SAFETY ALERT SA0003 Rev A

EFFECTIVE DATE: This Safety Alert is effective October 25, 2006
SUBJECT: Exhaust Strut Installation
MODELS AFFECTED: CC11-100 S/N CC11-00001 thru CC11-00004.
COMPLIANCE TIME: Prior to Next Flight
PURPOSE: Exhaust Strut Installation
PARTS LIST:

Figure 1 – Left Exhaust Strut

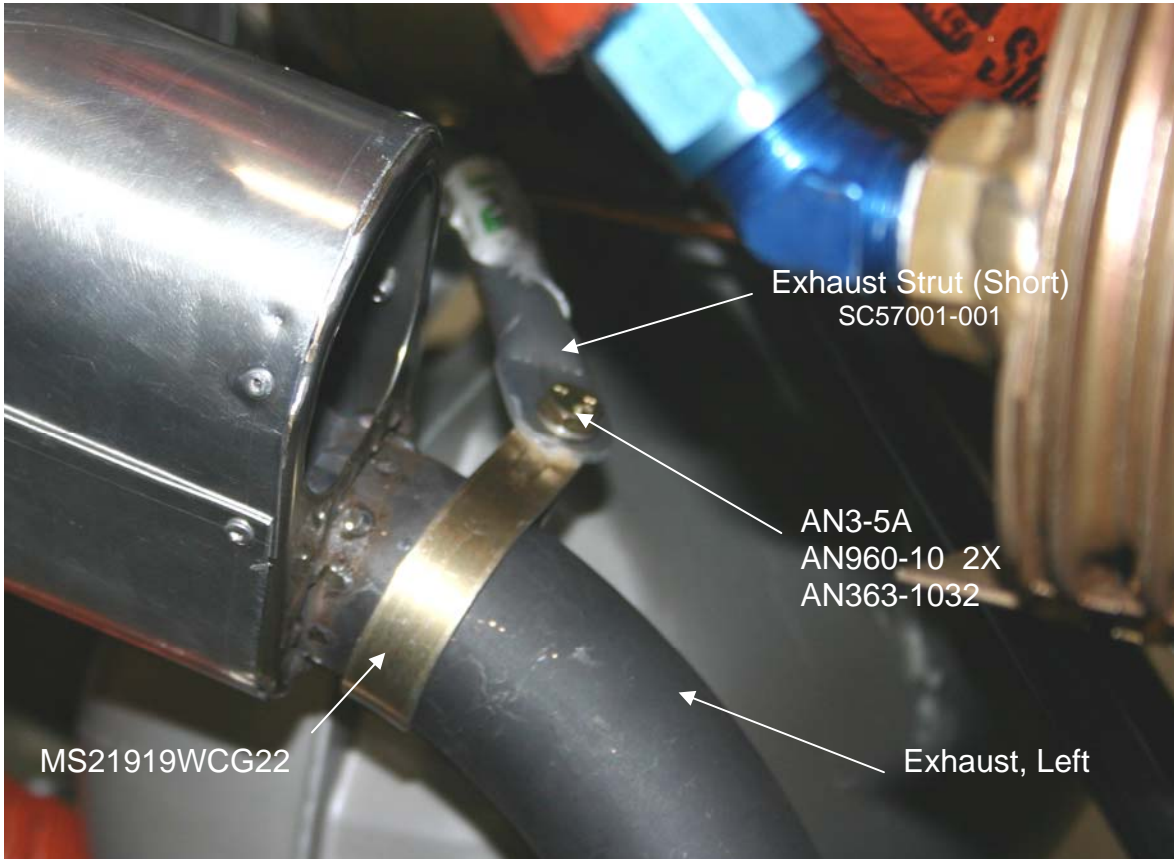
1. Remove cushion from both Adel Clamps (MS21919WCG22).
2. Place Adel Clamp (MS21919WCG22) around Left Exhaust (See Figure 1)
3. Secure MS21919WCG22 to unbent end of Exhaust Strut (SC57001-001) using AN3-5A, two (2) AN960-10, and AN363-1032. (See Figure 1)
4. Secure the bent end of the Exhaust Strut (SC57001-001) to the lower left Engine Mount stud using the existing engine mount hardware. (See Figure 2)
5. Torque AN363-1032 to 30 to 32 in·lbs.
6. Torque Engine Mount nut to 120 to 145 in·lbs.

Figure 3 – Right Exhaust Strut Attachment to Oil Pan

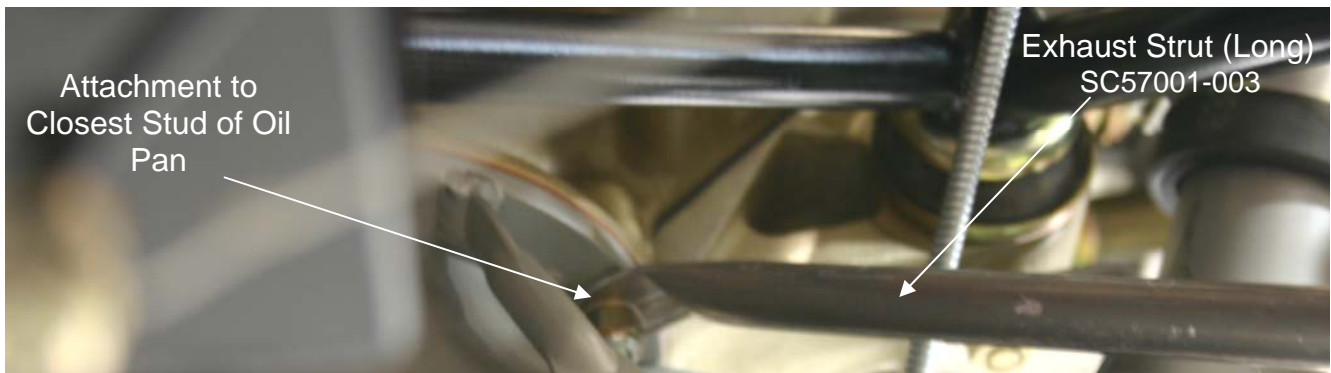
1. Secure bent end of Exhaust Strut (SC57001-003) to closest stud of oil pan using existing oil pan hardware. (See Figure 3) Oil pan may be lowered to remove nut.
2. Place Adel Clamp (MS21919WCG22) around Right Exhaust (See Figure 4)
3. Secure MS21919WCG22 to Exhaust Strut (SC57001-003) using AN3-5A, two (2) AN960-10, and AN363-1032. (See Figure 4). Bend strut ends, as necessary, for clamp attachment.
4. Torque oil pan nuts to 60 to 70 in-lbs.
5. Torque AN363-1032 to 30 to 32 in-lbs.
